DEVIATION REQUEST (Attach diagrams, figures, and other documentation to clarify request)

A deviation from the standards of or in Section **2.3.4** of the Engineering Criteria Manual (ECM) is requested.

CONSTRUCTION DOCUMENTS FOR:
THE COMMONS AT FALCON FIELD
 FILING No. 2
 12445 RIO LANE, AND VACANT LAND
 PEYTON, EL PASO COUNTY, COLORADO

TODDY WAY
PLAN & PROFILE

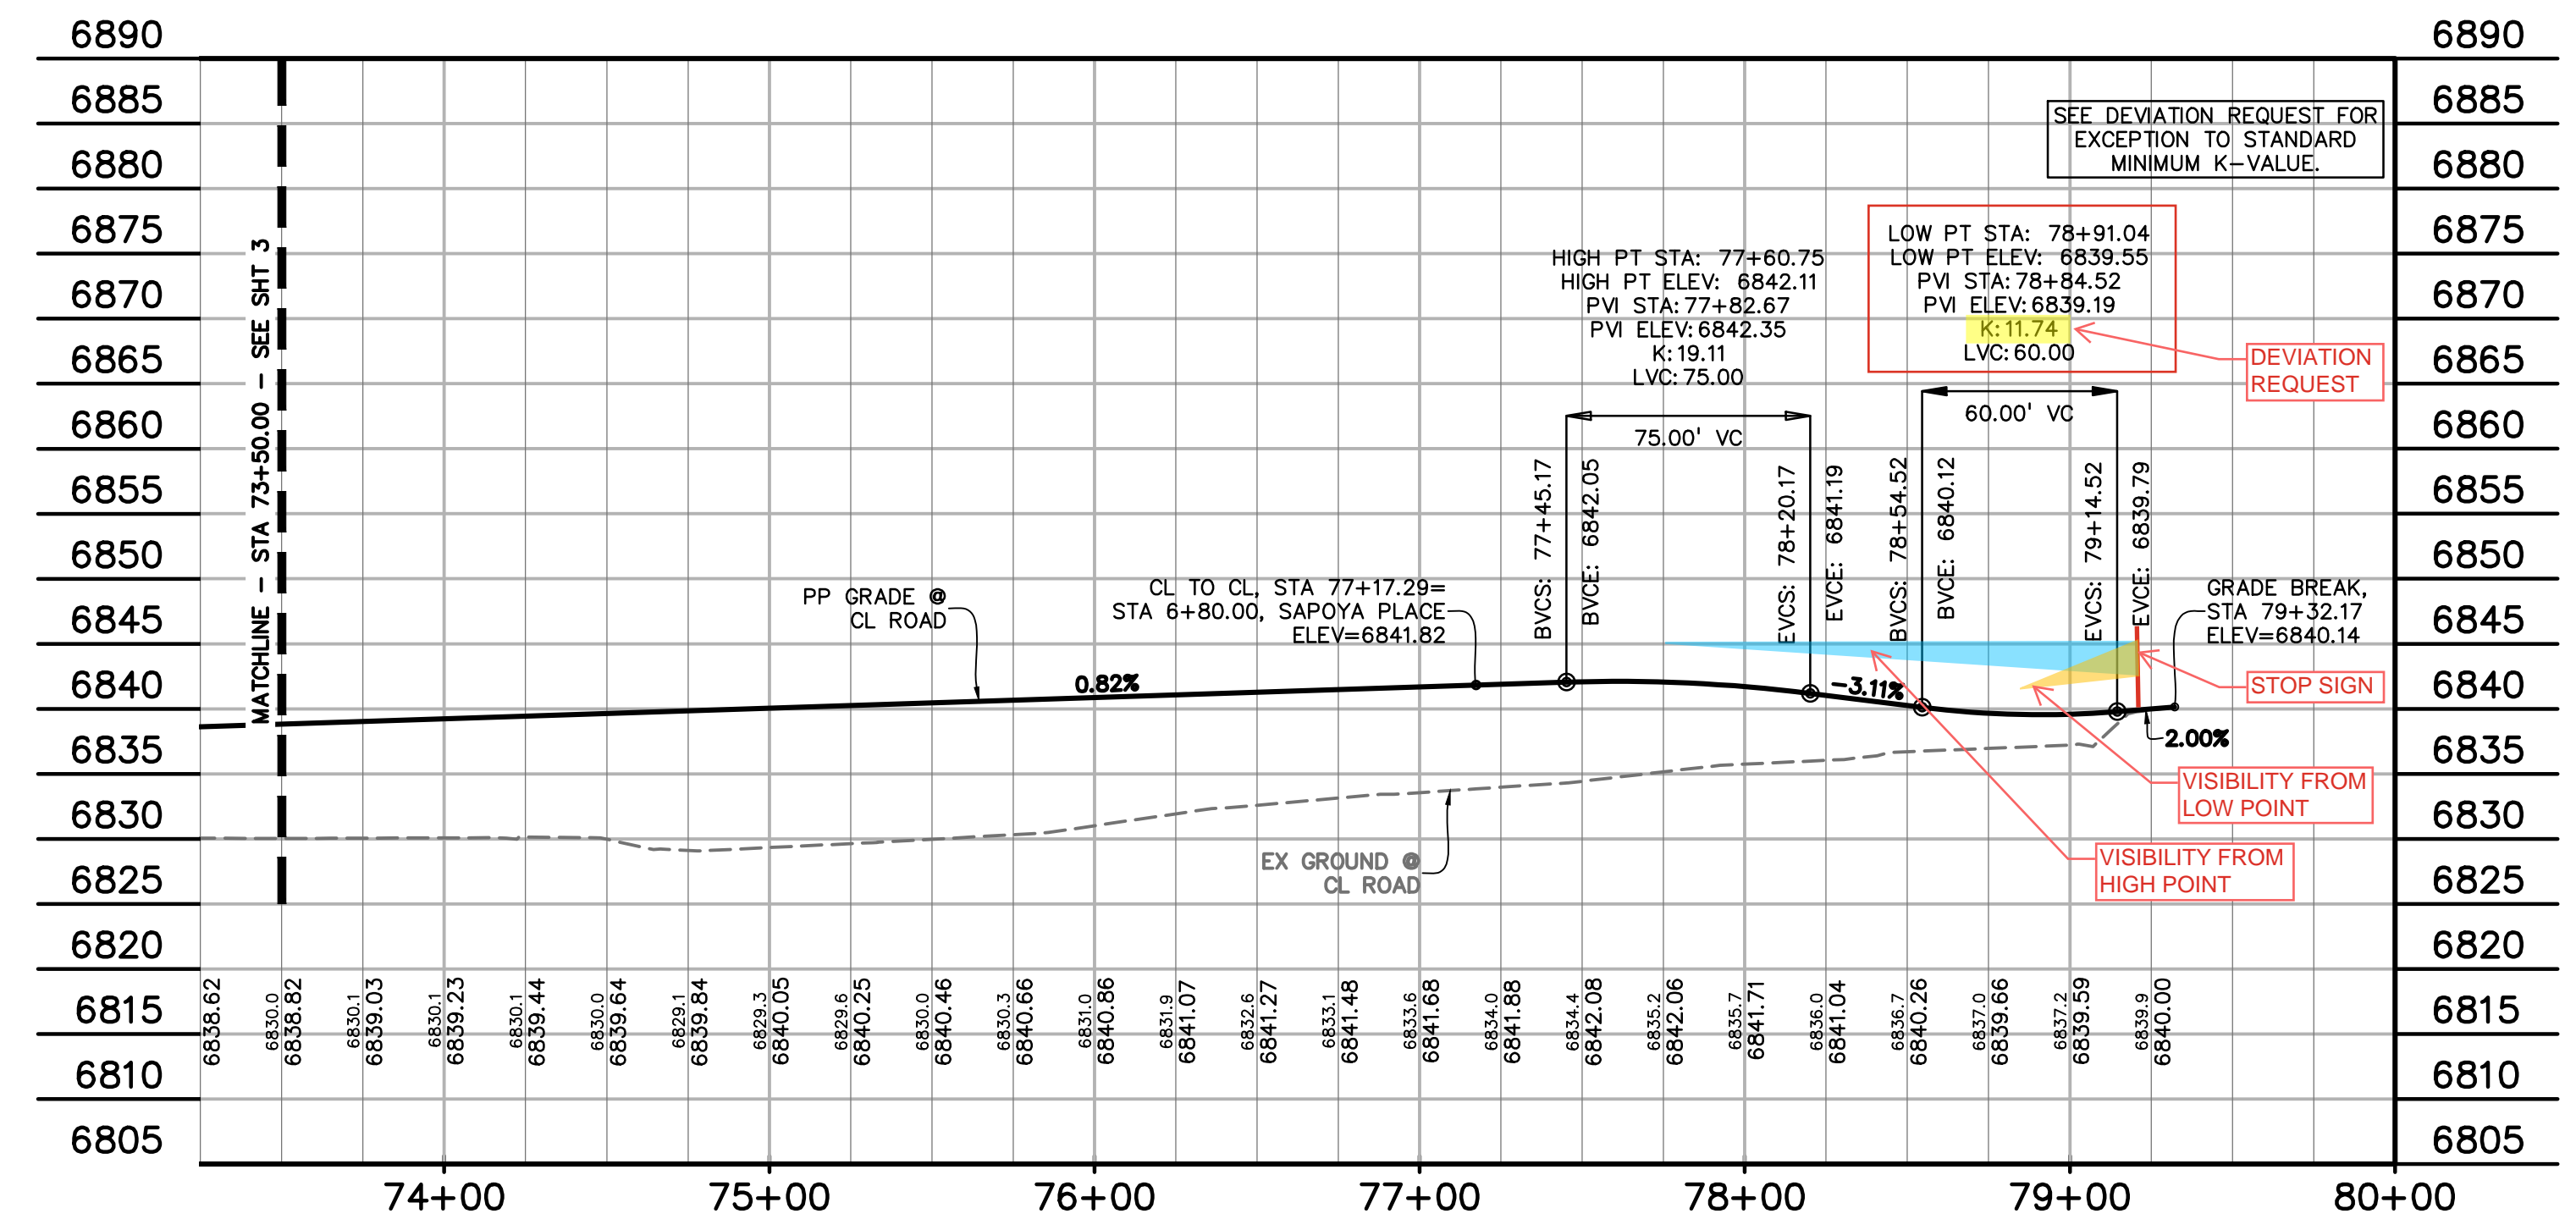
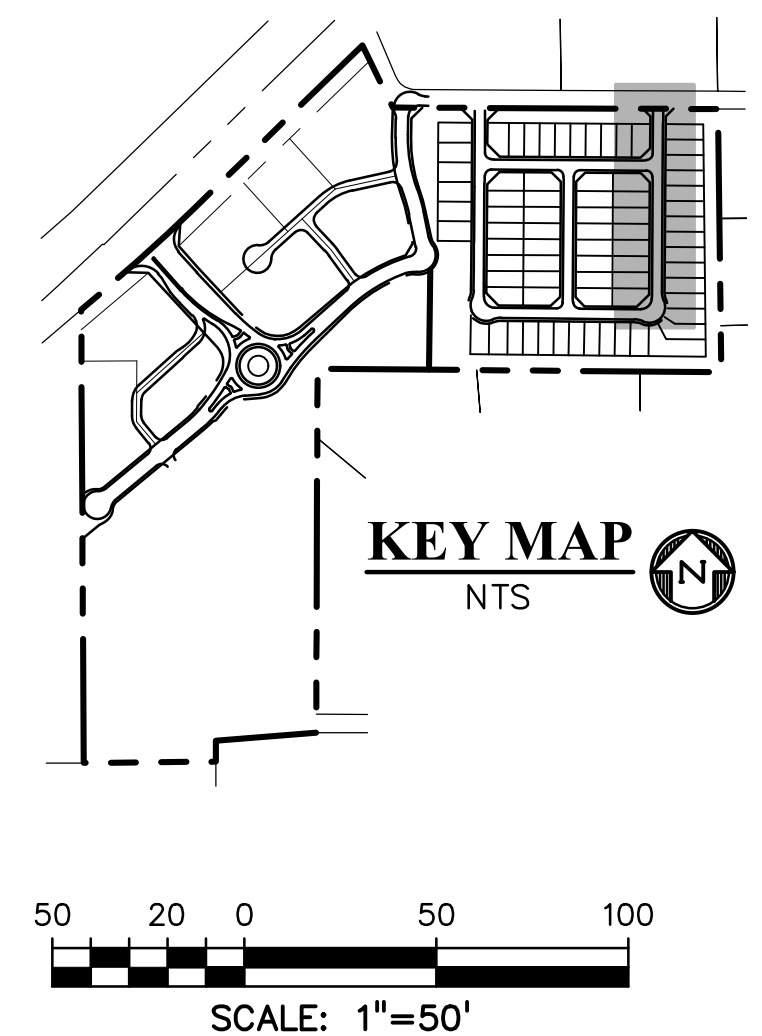
Section 2.3.4.A.2 "Table 2-14 and Figure 2-20 show the required lengths of sag vertical curves for different algebraic differences in grade to provide required stopping sight distances for each design speed."

Per Table 2-14. Design Controls for Stopping Distance on Sag Vertical Curves, the minimum Rate of Vertical Curvature, K has a minimum design value of 26 for a design speed of 25 mph.

A sag-curve k-value lower than the standard is necessary in order to meet the cross-slope of the Rio Lane and provide a low point immediately to the south on Tody Way to capture drainage flows.

Designing the vertical curves using the standard minimum k-value would result in a much longer vertical curve and/or increased cross slope for Rio Lane. This design creates a true low point with sufficient depth capacity in order to capture Tody Way roadway flows before they reach Rio Lane, while maintaining the standard 2% cross slope at Rio Lane.

Meeting the 2% cross slope of Rio Lane in conjunction with the longitudinal slope of the Tody Way, the minimum K-value for a sag curve per the ECM would require a vertical curve distance greater than the site constraints allow in order to capture drainage in the low point.

A lower K value than the design minimum is reasonable given the stop conditions present at the Tody Way intersection with Rio Lane. The horizontal distance for this intersection as designed does not negatively impact the driving conditions, as a driver traveling north would still be able to see the upcoming intersection and stop sign.

Due to the stop condition at Rio Lane, drivers will already be slowing to a lower speed. Therefore, the required stopping sight distance is diminished.

The intent and purpose of the k-value in a sag vertical curve is to ensure that the driver has adequate stop distance. Due to the stop condition at Rio Lane, drivers will already be decreasing speed allowing the lower k-value to provide the required stop distance.
